Work Order ID 64481

Item Name: Plate, Aft Support

DART AEROSPACE LTD	Work Order:	64481
Description: PLATE, AFT SUPPORT	Part Number:	D4274-3
Inspection Dwg: D4274-3, Rev: C		Page 1 of 1

From: Mike Petsche [mailto:mpetsche@dartaero.com]
Sent: December 6, 2010 1:55 PM
To: Sridhar Chintapalli; 'Chris Provencal'; 'L Lacelle'; 'Eric Charbonneau'; 'David Duval'
Cc: 'David Shepherd'
Subject: NEW PARTS PLEASE!!!!
Importance: High

D4274-3 PLATE, AFT SUPPORT

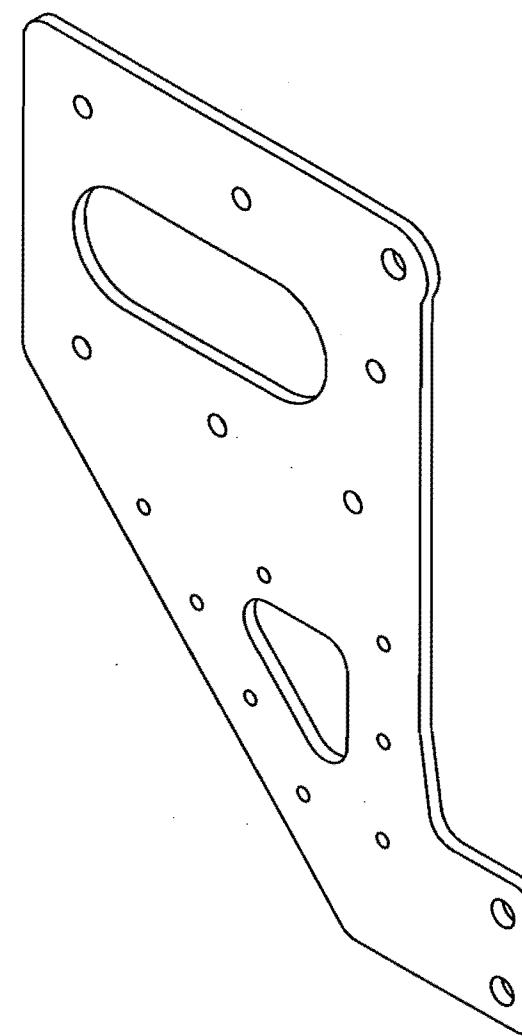
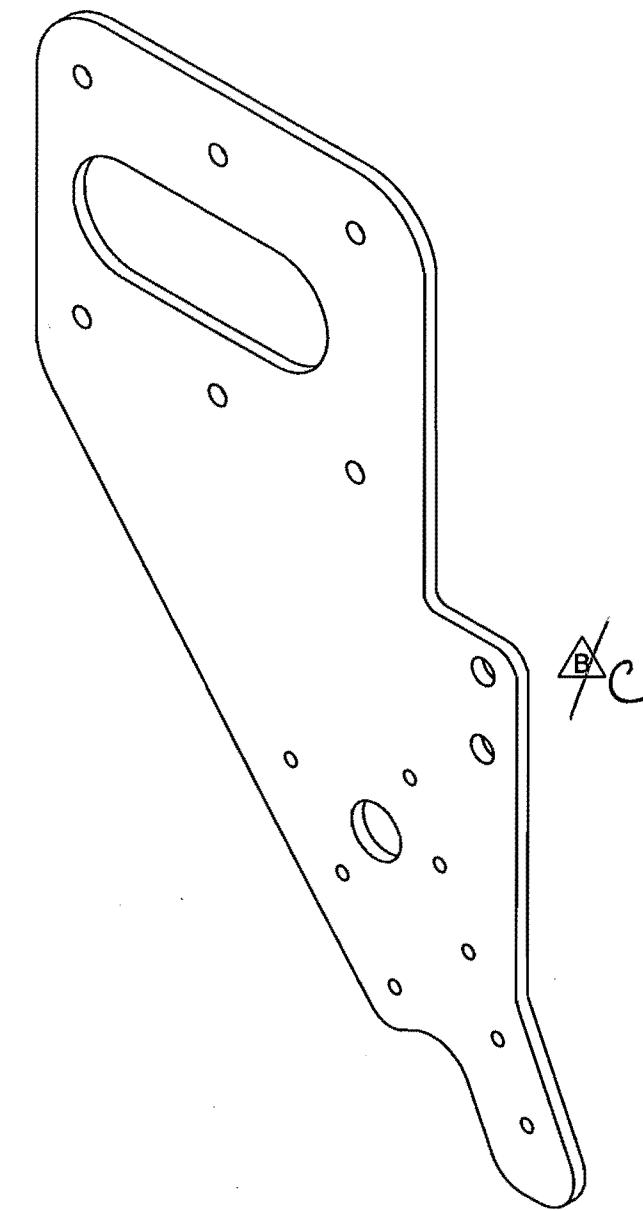
B	D4274-1, D4274-3 PLATES LENGTH INCREASED BY 0.25"; HOLES OPENED TO 0.25" FOR AN4 BOLTS		SC	10.12.02
A	NEW ISSUE		SC	10.11.30
REV.	DESCRIPTION			BY DATE
DESIGN	JPH	DART AEROSPACE LTD HAWKESBURY, ONTARIO, CANADA	DRAWING NO. D4274 REV. B SHEET 1 OF 3	SCALE NTS
DRAWN	SC			
CHECKED	W			
MFG. APPR.	M			
APPROVED	W			
DE APPR.				
DATE	10.12.02	COPYRIGHT © 2010 BY DART AEROSPACE LTD THIS DOCUMENT IS PRIVATE AND CONFIDENTIAL AND IS SUPPLIED ON THE EXPRESS CONDITION THAT IT IS NOT TO BE USED FOR ANY PURPOSE OR COPIED OR COMMUNICATED TO ANY OTHER PERSON WITHOUT WRITTEN PERMISSION FROM DART AEROSPACE LTD.

0.5"

D4274-3 PLATE, AFT SUPPORT

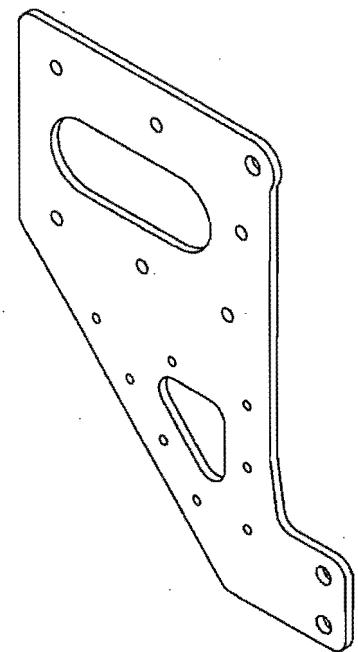
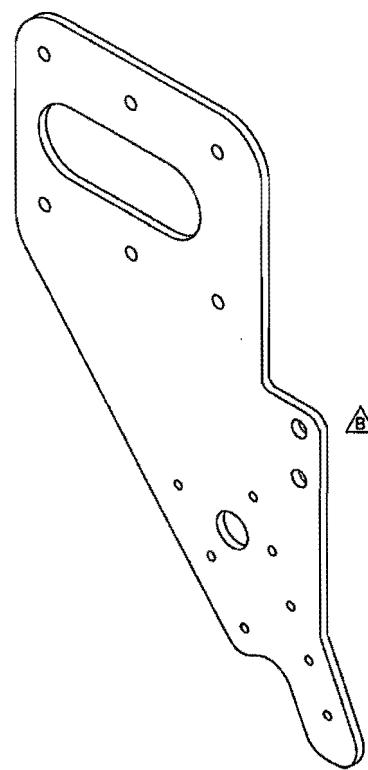
I know it's a little late in the game.... But Sri, as I mentioned in my email this weekend, The basket is still a little too high for the 407

Could you drop everything right away and modify the D4274-1 and D4274-3 plates to make them an additional $\frac{1}{2}$ " taller than they are. Basically do exactly what you did before. But we need an additional $\frac{1}{2}$ "

B	D4274-1, D4274-3 PLATES LENGTH INCREASED BY 0.25"; HOLES OPENED TO 0.25" FOR AN4 BOLTS			SC	10.12.02
A	NEW ISSUE			SC	10.11.30
REV.	DESCRIPTION			BY	DATE
DESIGN	JPH	DART AEROSPACE LTD HAWKESBURY, ONTARIO, CANADA			
DRAWN	SC				
CHECKED	W	DRAWING NO. D4274			REV. B
MFG. APPR.	W				SHEET 1 OF 3
APPROVED	W	TITLE PLATES, BASKET SUPPORT			SCALE NTS
DE APPR.					
DATE	10.12.02	COPYRIGHT © 2010 BY DART AEROSPACE LTD THE DOCUMENT IS THE PROPERTY OF DART AEROSPACE LTD. IT IS EXPLICITLY STATED THAT IT IS NOT TO BE USED FOR ANY PURPOSE OR COPIED OR COMMUNICATED TO ANY OTHER PERSON WITHOUT WRITTEN PERMISSION FROM DART AEROSPACE LTD.
